| REV. | FCR 3025-2 | NJA 7-14-81 | Rm 7-14-81 | gdl 7/17/81 | RWD 7/14/81 |

| ROBERT EMMETT GINNA NUCLEAR POWER STATION UNIT NO.1 ELEMENTARY WIRING DIAGRAM TURBINE TRIP AUX. RELAY | | DATE | SCALE | APPROVED | FOLDER NO. | JOB NO. |
| ROCHESTER GAS & ELECTRIC CORP. ROCHESTER, NEW YORK | | No. 10905-114 ENG'R DEPT | | | | |

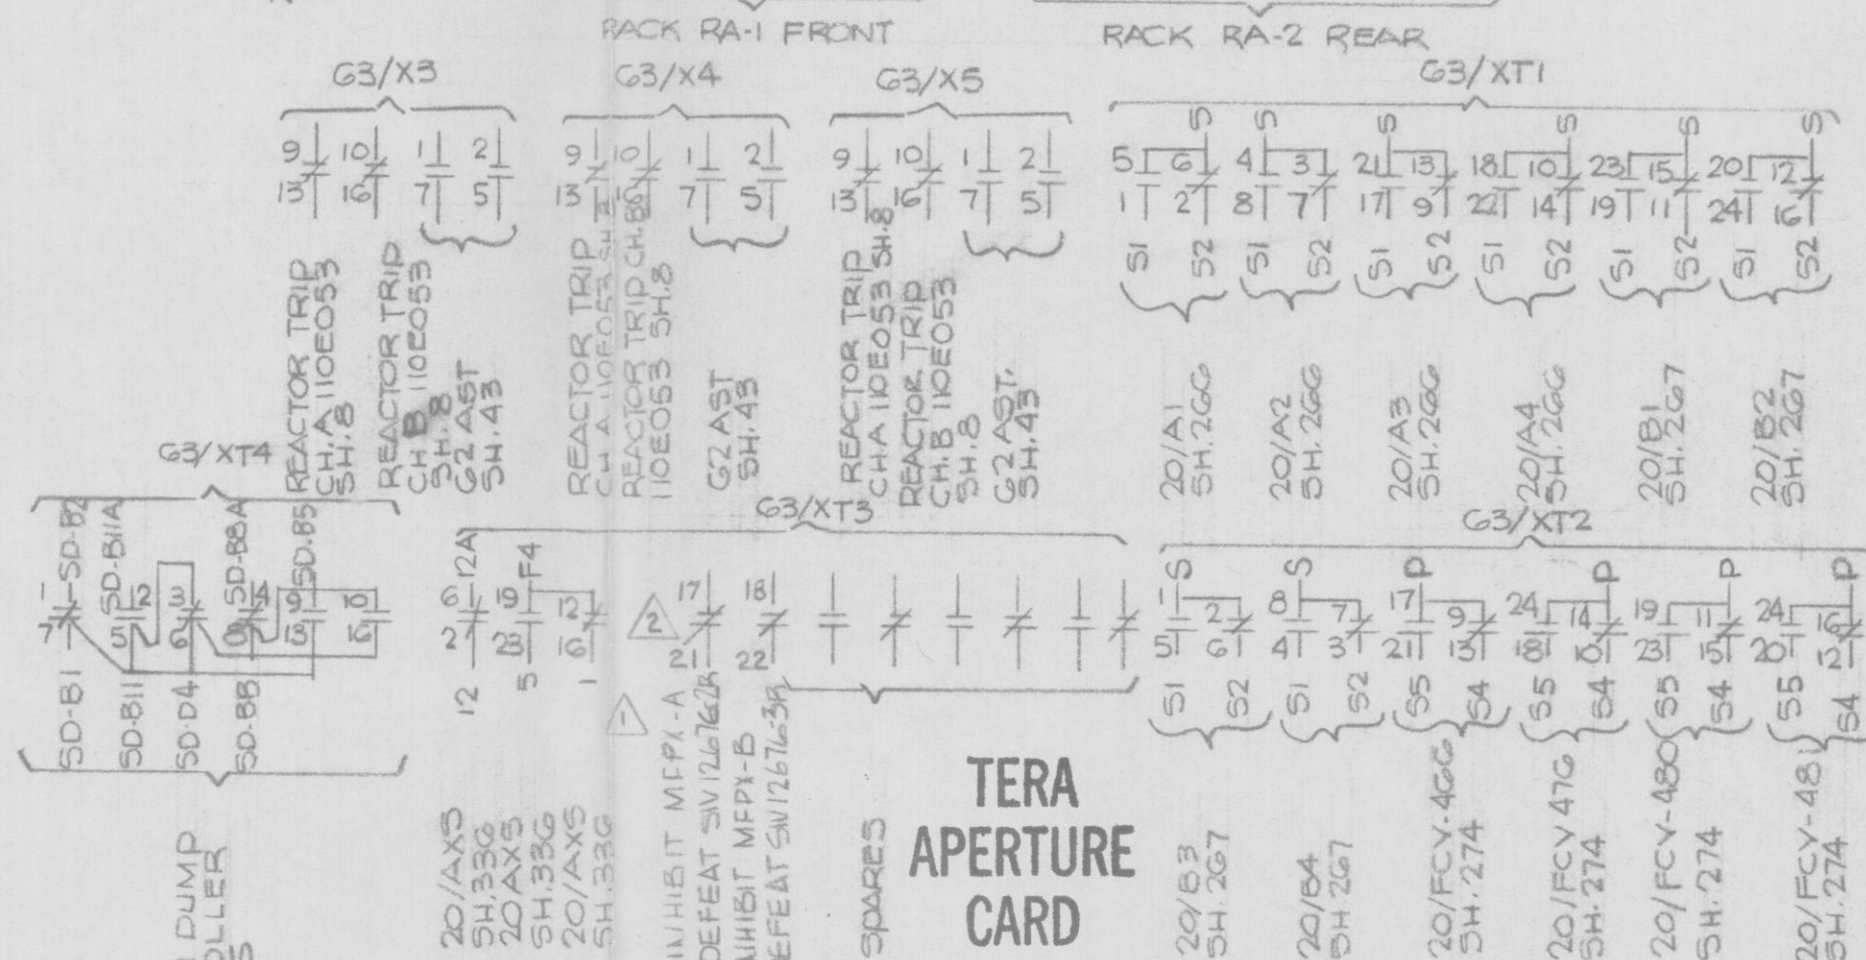
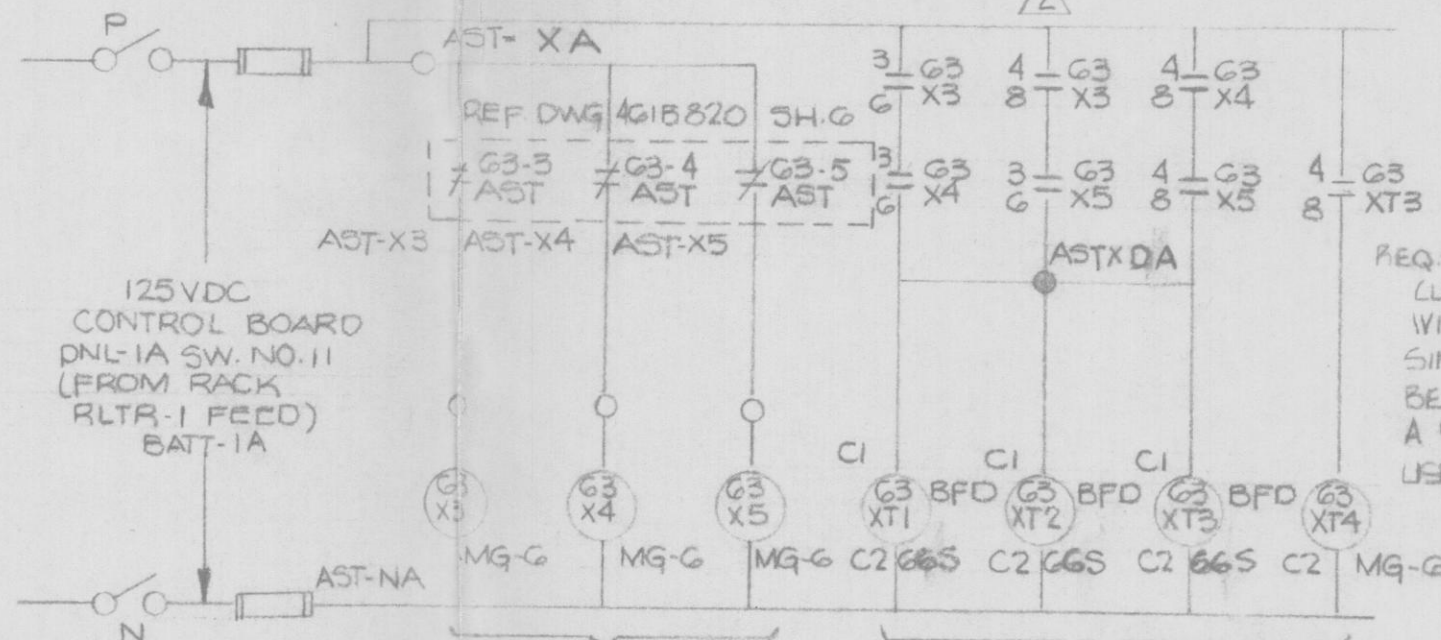
REQ: 63XT3/TD CONTACT
 CLOSED WHEN ON LINE
 WITH TD ON OPENING.
 SINCE 63XT3/TD SHOULD
 BE DE-ENERGIZED THEN
 A "b" CONTACT WILL BE
 USED.
